REFERENCE: Groundwater Registration Modification Application T-14001

SUBJECT: Groundwater Registration Modification T-14001

PRELIMINARY DETERMINATION  
PROPOSING APPROVAL OF RECOGNITION  
OF ADDITIONAL POINTS OF  
APPROPRIATION

# Groundwater Transfer Review Summary Form

Groundwater Registration Modification Map  
GR-1658

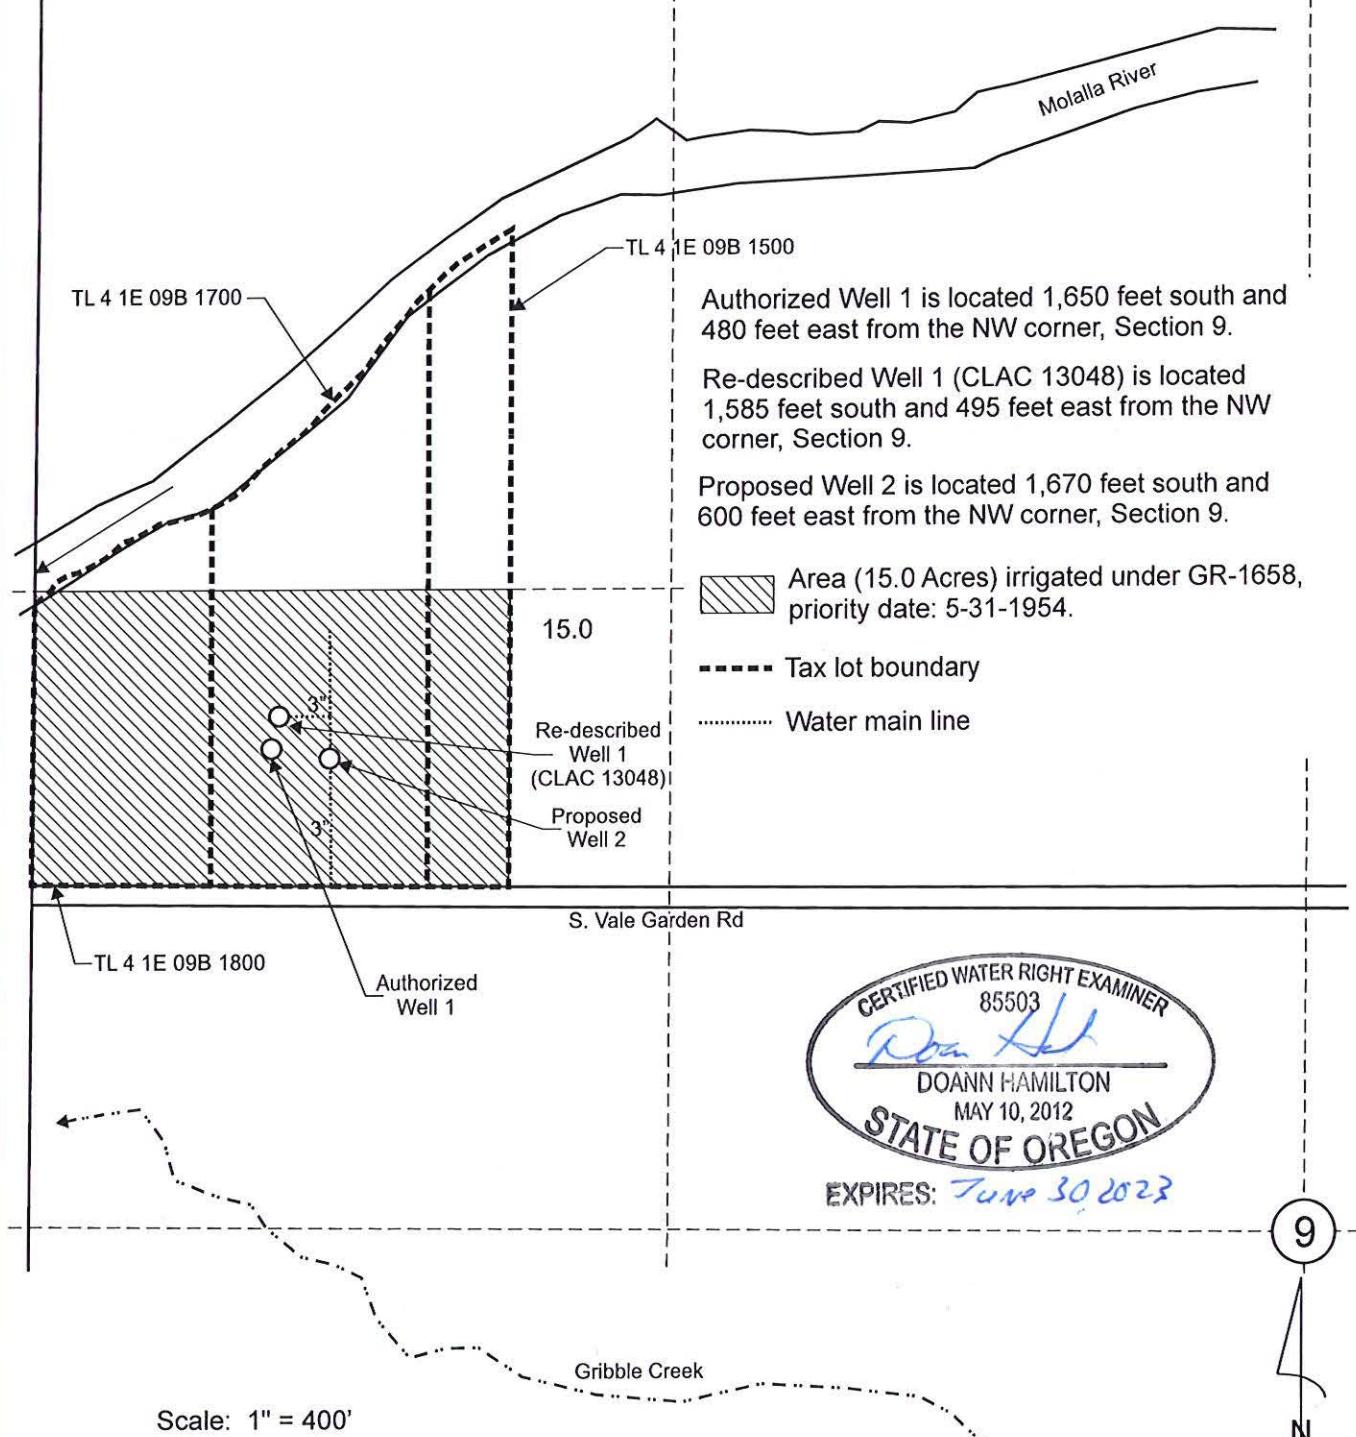
Our client Leonard and Carol Wilke have asked me to make revisions to their groundwater registration modification T-14001 on GR-1658 submitted May 9, 2022. They wish to relocate the proposed Well 2. Attached is the revised map and page 5 of the application showing revisions to Table 1. Please let me know if there is any additional information I need to provide to make this change.
